## Omaha Public Power District

LIC-82-208

### Adequacy of the Fort Calhoun Station Electrical Distribution System Voltages

CURVE NO: S.T.

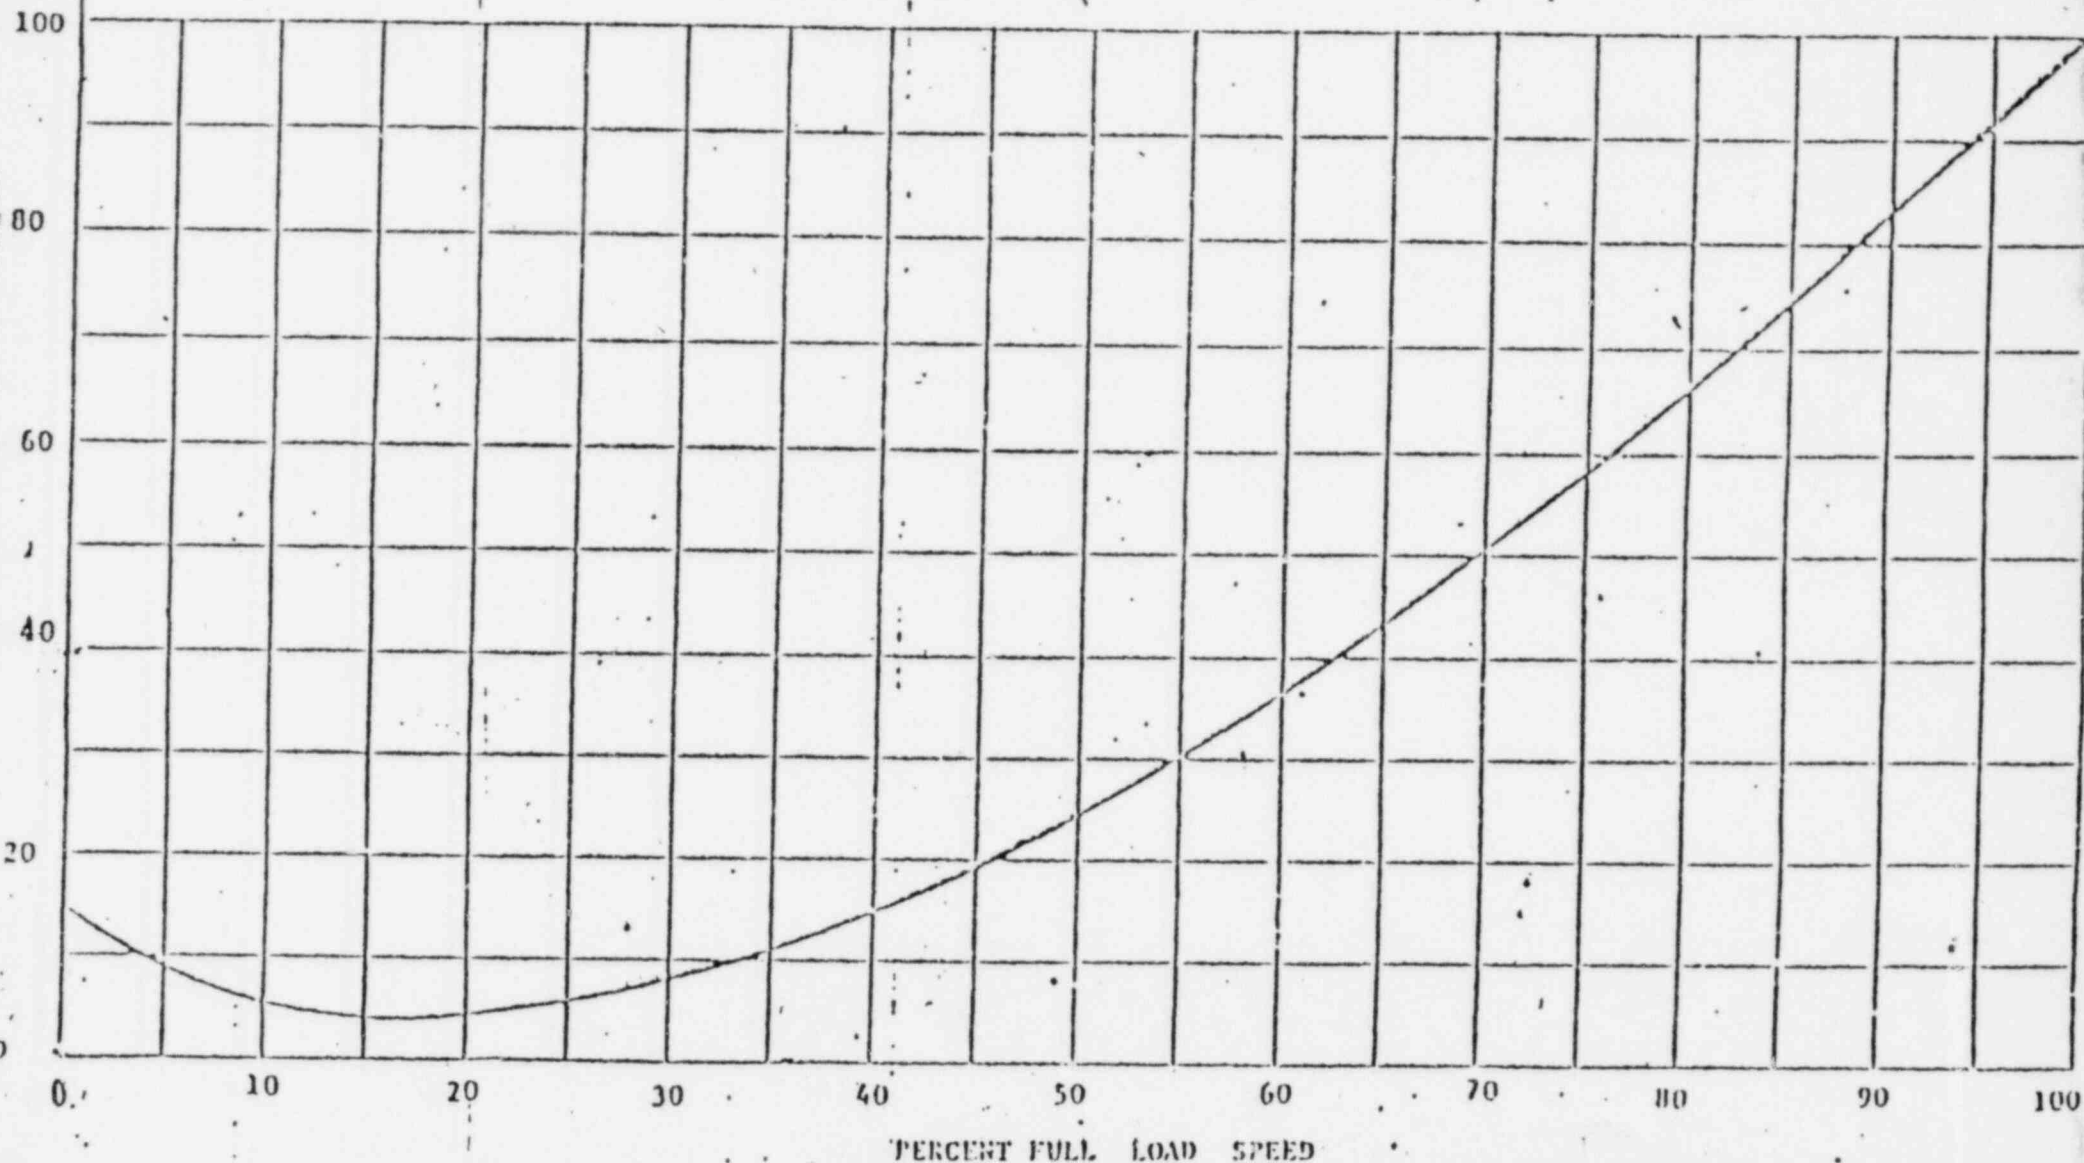
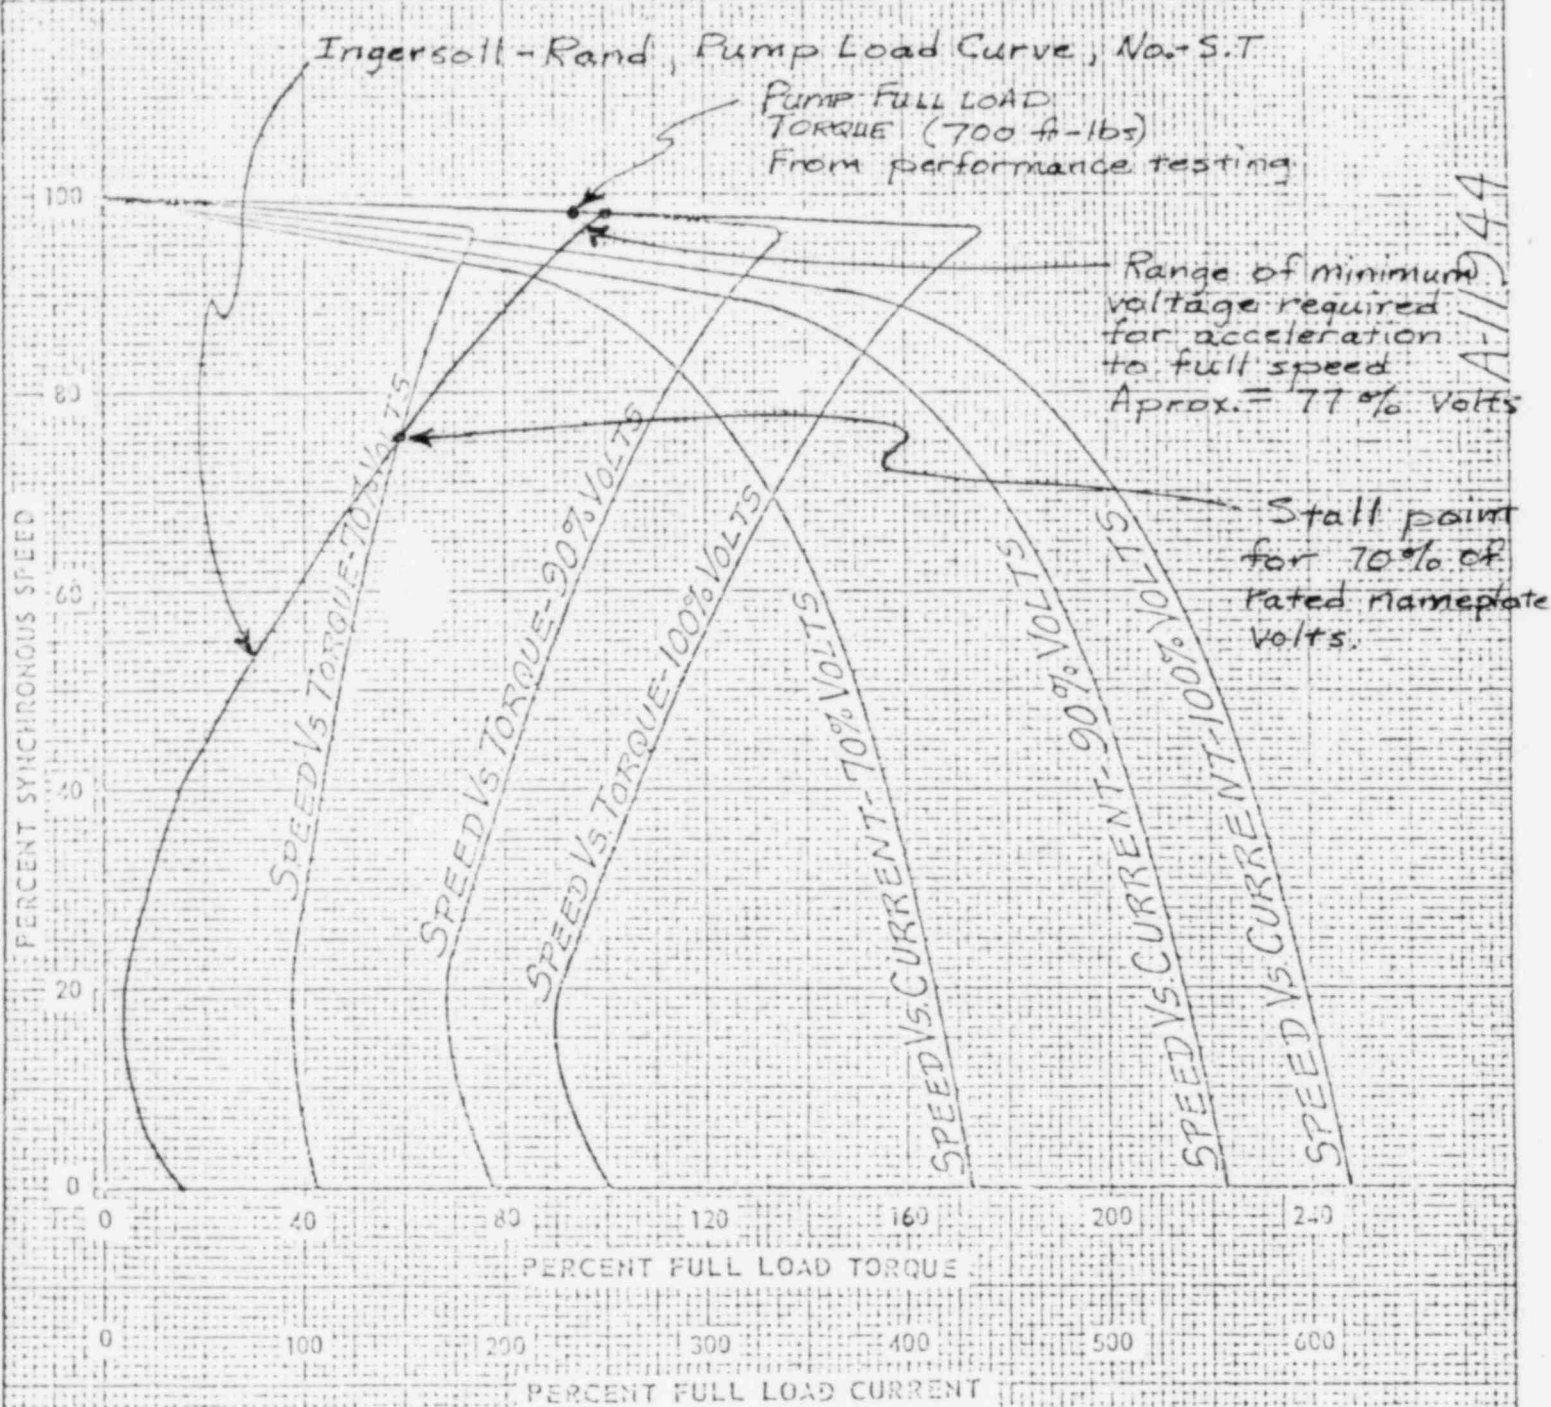
The following discussion summarizes the District's position regarding the operation of the CCW pumps with respect to off-normal voltage levels. The attached CCW pump speed-torque curve (Curve No. S.T.) provided by Ingersoll-Rand has been superimposed on the speed-torque curves (Drawing A-11944) for the CCW pump motor to facilitate the undervoltage analysis. Based on attached Drawing A-11944, the following sequence of events would occur if the CCW pumps were started at 70% of

nameplate voltage. The motor and pump would accelerate to 75% of synchronous speed, then the pump-motor combination would stall due to the pump torque requirements being greater than the torque output of the motor. At 75% synchronous speed (1350 RPM), the motor would be drawing approximately 315% of full load current. Utilizing attached Drawing A-11945, approximately 1.7 seconds would elapse from the time of initial motor energization until reaching the stalled condition at 75% rated speed. After the motor stalls, it would continue to draw 315% of full load current for approximately 30 to 110 seconds, during which time the motor circuit breaker would trip due to overcurrent. This overcurrent trip is designed to protect the motor during starting from the consequences of a locked rotor and the subsequent overheating of the motor due to a lack of air flow. However, in the case of the overcurrent trip being induced by undervoltage, the motor at trip would be operating at approximately 1350 RPM, creating a significant air flow across the motor for cooling purposes. Thus, the consequences of the CCW motor overheating due to undervoltage conditions is less severe than that due to a locked rotor, therefore, the CCW motor is fully protected from damage due to an overcurrent trip induced by an undervoltage condition. The 70% of nameplate voltage was selected for this illustrative undervoltage example because the lowest CCW motor speed-torque curve was drawn at this level. The previously described sequence of events would only occur in the event of an undervoltage relay failure because these relays are presently set to trip at 72%-77.3% of bus voltage with a minimum time delay of 8 seconds. However, 72% of 460 volts at the bus corresponds to approximately 70% of 460 volts at the motor's terminals. Therefore, the undervoltage relays would trip the entire bus before the overcurrent protection would trip the individual motors.

A-11944

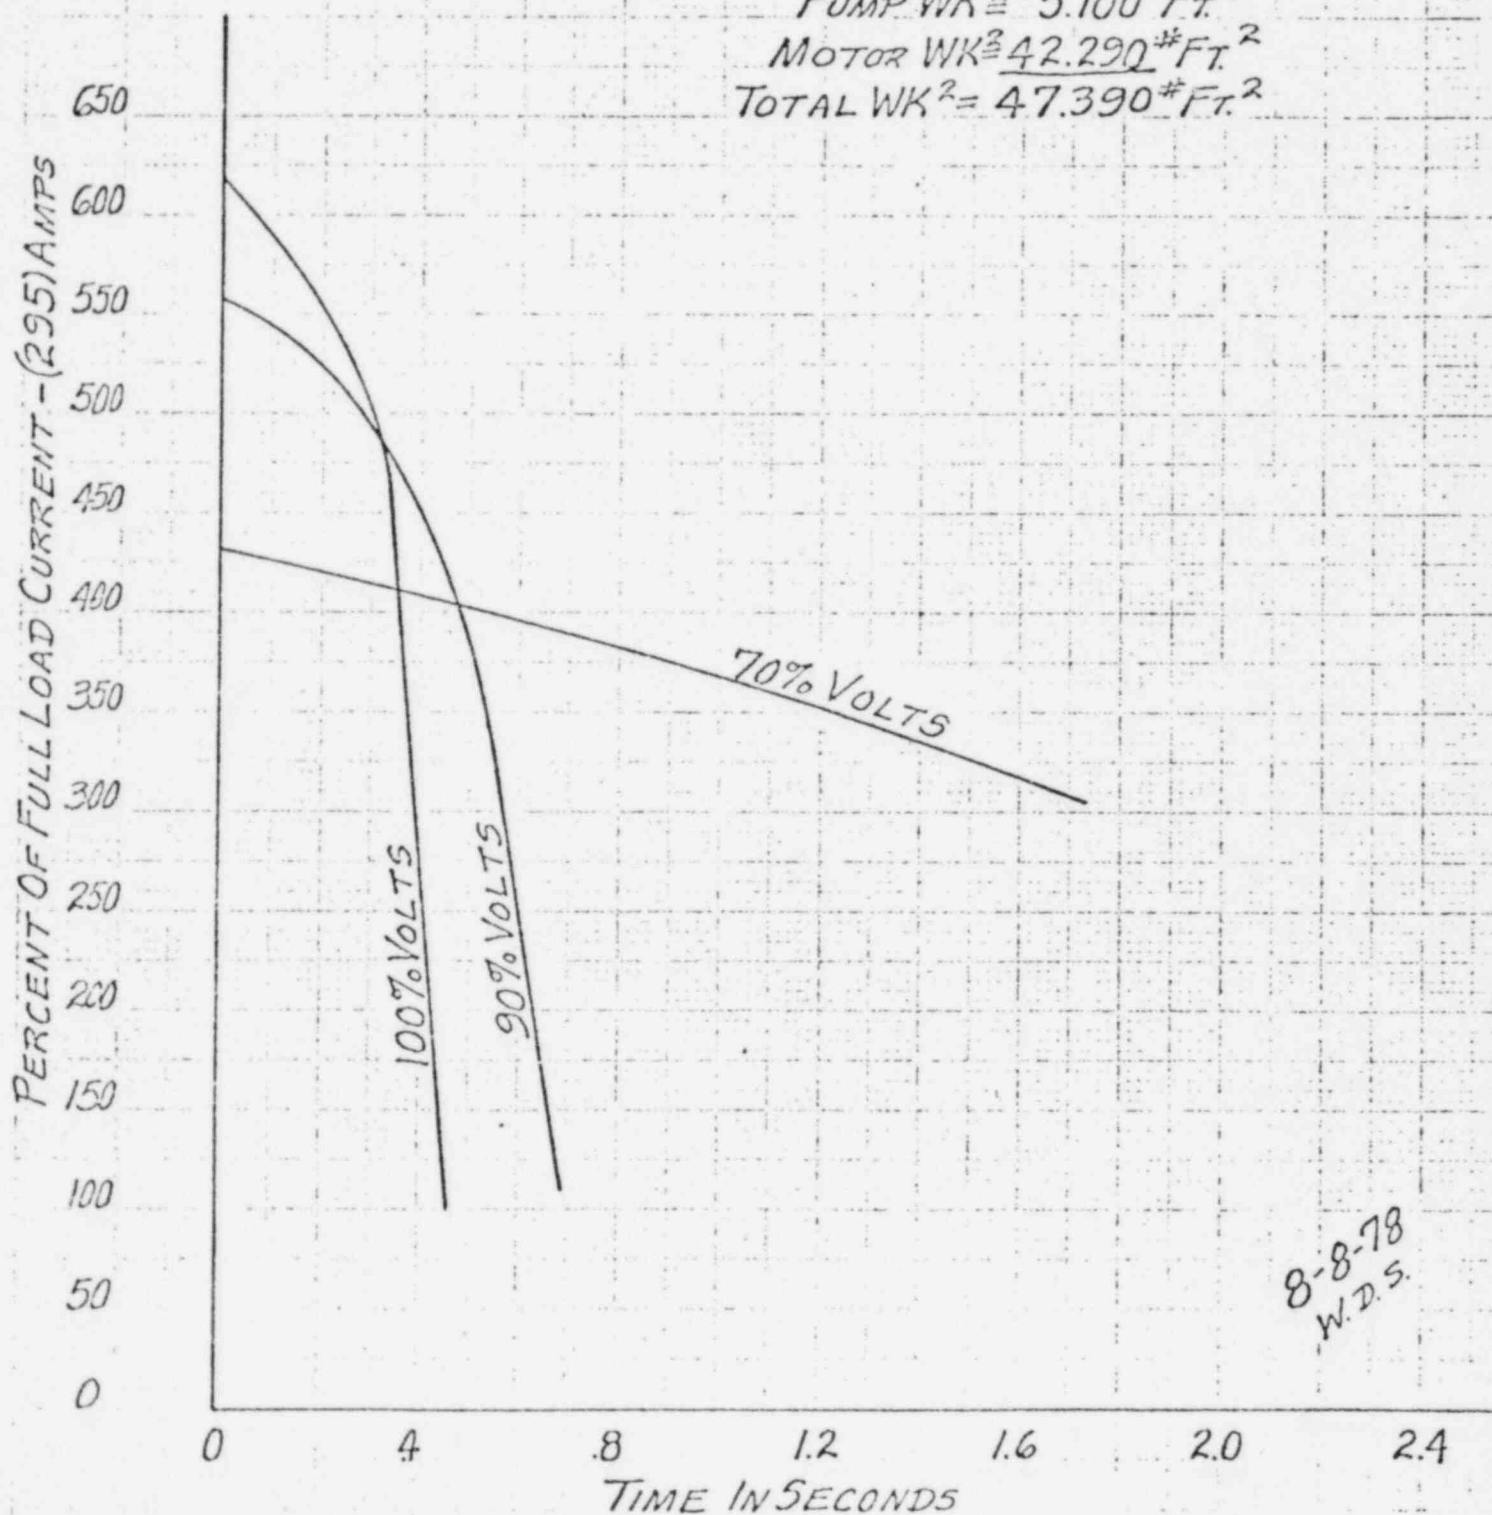
The next relevant point of discussion is the minimum voltage required to successfully accelerate the CCW pump-motors to full speed and thus, to a safe operating level. Interpolating between the 70% voltage curve and the 90% voltage curve (Drawing A-11944), it is demonstrated that the motors reach breakdown torque at approximately 77% of nameplate voltage. This 77% minimum operating level corresponds well with the 77.3% maximum undervoltage bus trip setting.

Based on the information provided in the District's March 19, 1982 letter and the above analysis for the CCW pump motors, the District believes these motors are adequately protected from damage due to undervoltage conditions. Also, the existing undervoltage relay setpoints provide sufficient protection for the CCW motors and presently there is no reason to raise the setpoints.
